Architectural Review and
Historic Preservation Board
Agenda Report

File: AR 17-03

RE: Architectural Review 17-03 (Meriam Park Foundation Building) – Lot B2 of
Subdivision S09-01 (APN 002-180-157, portion)

SHEET L-0.2

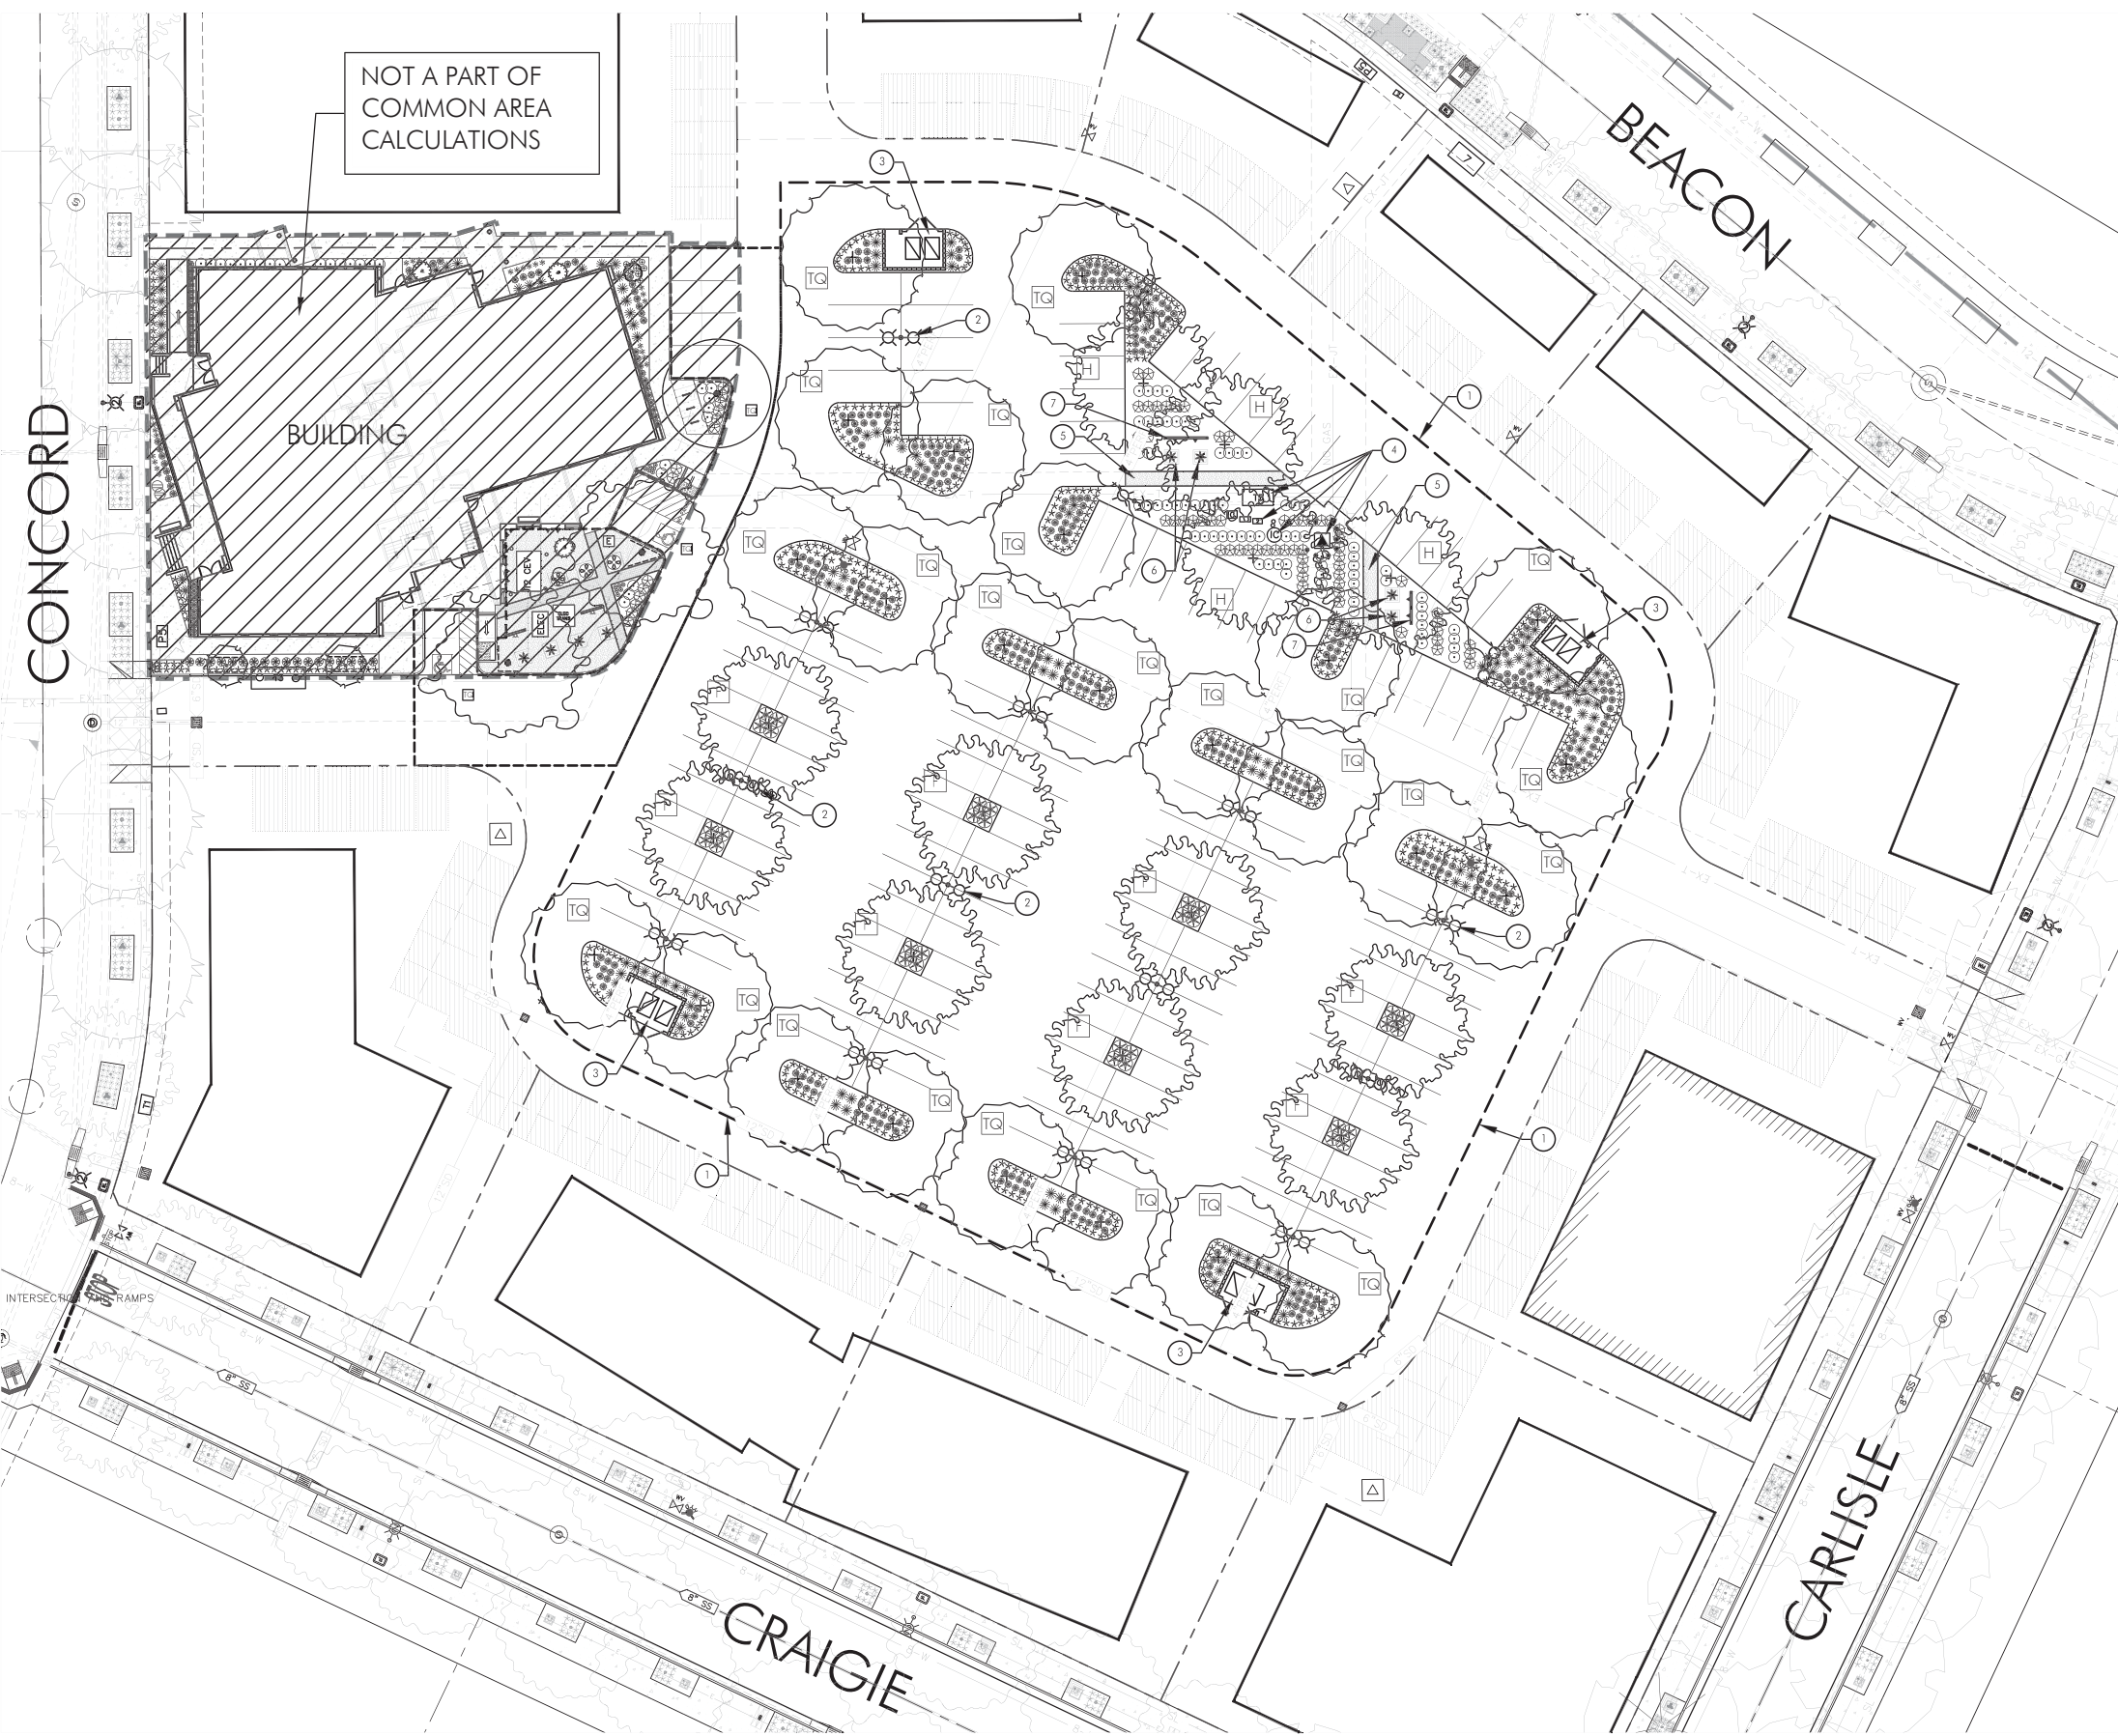
Parking Lot Lighting: Given that a mitigation measure from the Environmental Impact Report (EIR) states: “where possible, limit height of light standards to 12 feet,” discuss whether or not the proposed 16-foot tall fixtures are necessary in this instance. To be consistent with provisions of Mitigation Measure AES-1, a condition is recommended to limit the new light standards to 12 feet in height.

1. The front page of all approved building plans shall note in bold type face that the project shall comply with Architectural Review 17-03 (Meriam Park Foundation Building). No building permits related to this approval shall receive final approval without prior authorization of Community Development Department Planning staff.
2. All development shall comply with all other State and local Code provisions, including those of the City of Chico Community Development and Public Works Departments. The permittee is responsible for contacting these offices to verify the need for compliance.
3. All parking lot lighting shall be limited to 12-feet in height.
